AMENDED PROPOSED

SEPTIC SYSTEM PLAN

LOCUS: LOT 9 MARTHA'S COURT
HAMPTON FALLS, NH

* AMENDED 4/15/92 HOUSE, SEPTIC TANK & DRAINS ONLY

CROSS SECTION DISPOSAL SYSTEM - NOT TO SCALE

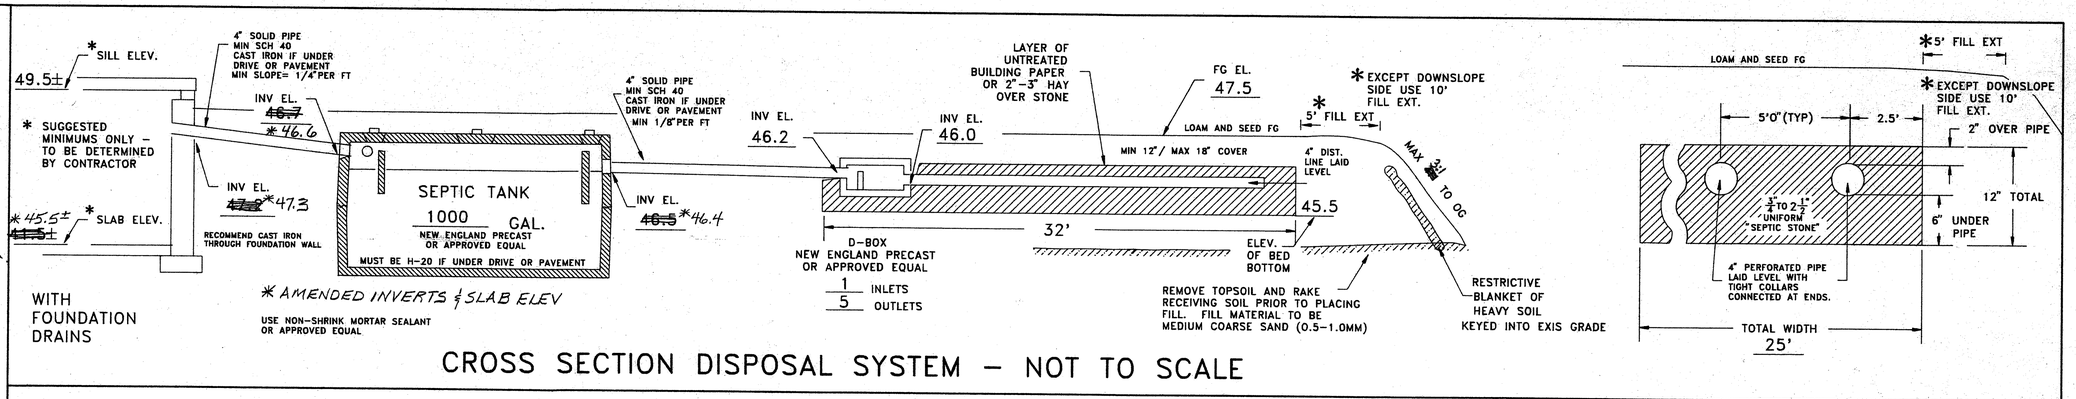
* SILL ELEV.
49.5±
4" SOLID PIPE MIN SCH 40 CAST IRON IF UNDER DRIVE OR PAVEMENT MIN SLOPE= 1/4"PER FT
INV EL. ~~46.7~~ *46.6
* SUGGESTED MINIMUMS ONLY - TO BE DETERMINED BY CONTRACTOR
INV EL. ~~47.2~~ *47.3

* ~~45.5±~~ *45.5±
* SLAB ELEV.
RECOMMEND CAST IRON THROUGH FOUNDATION WALL
SEPTIC TANK
1000 GAL.
NEW ENGLAND PRECAST OR APPROVED EQUAL
MUST BE H-20 IF UNDER DRIVE OR PAVEMENT
4" SOLID PIPE MIN SCH 40 CAST IRON IF UNDER DRIVE OR PAVEMENT MIN 1/8"PER FT
INV EL. ~~46.5~~ *46.4
WITH FOUNDATION DRAINS

* AMENDED INVERTS & SLAB ELEV
USE NON-SHRINK MORTAR SEALANT OR APPROVED EQUAL
INV EL. 46.2
INV EL. 46.0
D-BOX NEW ENGLAND PRECAST OR APPROVED EQUAL
1 INLETS
5 OUTLETS
LAYER OF UNTREATED BUILDING PAPER OR 2"-3" HAY OVER STONE
FG EL. 47.5
LOAM AND SEED FG

CROSS SECTION DISPOSAL SYSTEM – NOT TO SCALE

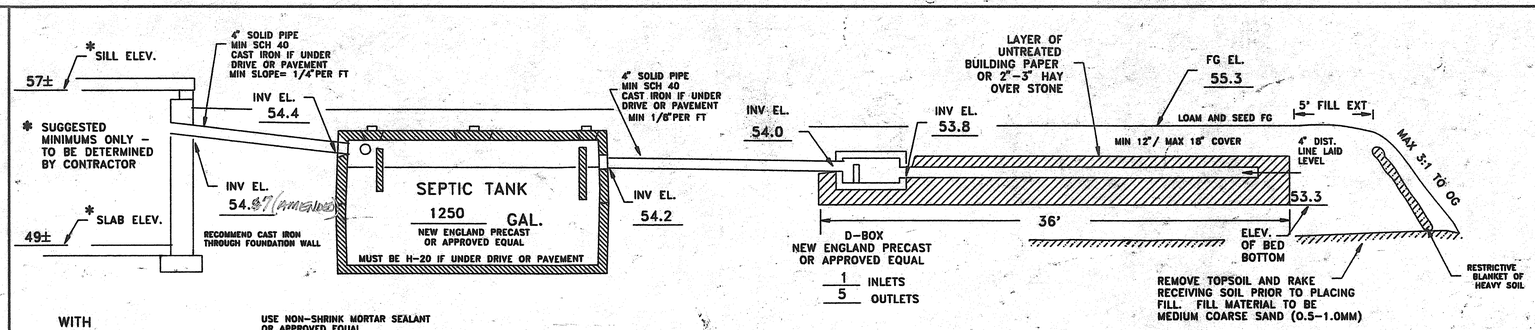
* SILL ELEV.
57±
4" SOLID PIPE MIN SCH 40 CAST IRON IF UNDER DRIVE OR PAVEMENT MIN SLOPE= 1/4"PER FT
INV EL. 54.4
* SUGGESTED MINIMUMS ONLY – TO BE DETERMINED BY CONTRACTOR
INV EL. 54.87 (AMENDED)
